**49 CFR Part 571**

[Docket No. NHTSA-2008-0068]

**Federal Motor Vehicle Safety Standards; Electronic Stability Control Systems; Controls and Displays**

**ACTION:** Final rule; response to petitions for reconsideration.

**Figure 1. Rotary Multi-mode Control Example**

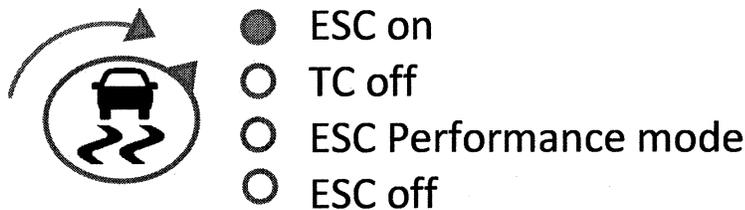
The Alliance/AIAM petitioned for clarification of paragraphs S5.4.2 and S5.4.3 regarding a control switch or button that combines several functions, which we will call a “multi-function” control for simplicity.<sup>14</sup> For background, paragraph S5.4.2 requires that an ESC control whose only purpose is to disable the ESC system or place it in a mode in which it no longer satisfies the performance requirements<sup>15</sup> be labeled either with the ESC symbol plus the word “Off” or the phrase “ESC Off.” The “ESC Off” telltale must also

The Alliance/AIAM offered the example of a multi-function control that could be used to turn ESC off or on, but could also be used to turn traction control off and to select an ESC “performance mode.” Because such a control could be seen as neither a control whose only purpose is to disable ESC, nor a control for another system with an ancillary effect, petitioners requested that the agency clarify that multi-function controls like the one described are not prohibited by FMVSS No. 126. Figure 1 below shows a rotary multi-function control (this example was provided in the petition).

*Agency response:* We are granting the petition to clarify S5.4.3, although we note that this question was already answered in the affirmative in the agency’s response to the GM request for interpretation. FMVSS No. 126 does not prohibit multi-function ESC controls that combine the control whose only purpose is to disable the ESC system with controls used for other purposes. Paragraph S5.4 specifically allows controls whose sole purpose is to disable ESC and establishes various requirements for them. The only reason that the standard distinguishes between these controls used only for disabling ESC from those used to control systems with an ancillary effect on ESC is to express the labeling requirements for the control symbols. The multi-function control example presented by the petition combines several controls in a single piece of hardware: one control whose only purpose is to disable ESC, one unregulated control for the traction control system, and another control that places the ESC system in an intermediate “sport” or “performance” mode.”

In the rotary multi-function control example of Figure 1, the function within the control that disables ESC, because its only purpose is to disable ESC,

would be required to be identified using the symbol or text specified in FMVSS No. 101 for “ESC Off” (effective September 1, 2011) on or adjacent to that part of the control. We would not consider the precise example given by the Alliance/AIAM petition as satisfying FMVSS No. 101’s requirement that the “ESC Off” label (“identifier”) be adjacent to the control it identifies, because the telltale lamp is located between the two.<sup>16</sup> However, this problem could be solved by moving the lamp to the other side of the label.

FMVSS No. 126 does not specify requirements for the “TC off” function in the example, nor for the “ESC Performance mode” function, unless that function within the control places the ESC system in a mode in which it no longer satisfies the standard’s performance requirements. If it did, it would be considered an “ESC Off” control (because it is a control whose purpose is to place the ESC system in a mode in which it no longer satisfies the performance requirements) and would also have to be labeled accordingly.
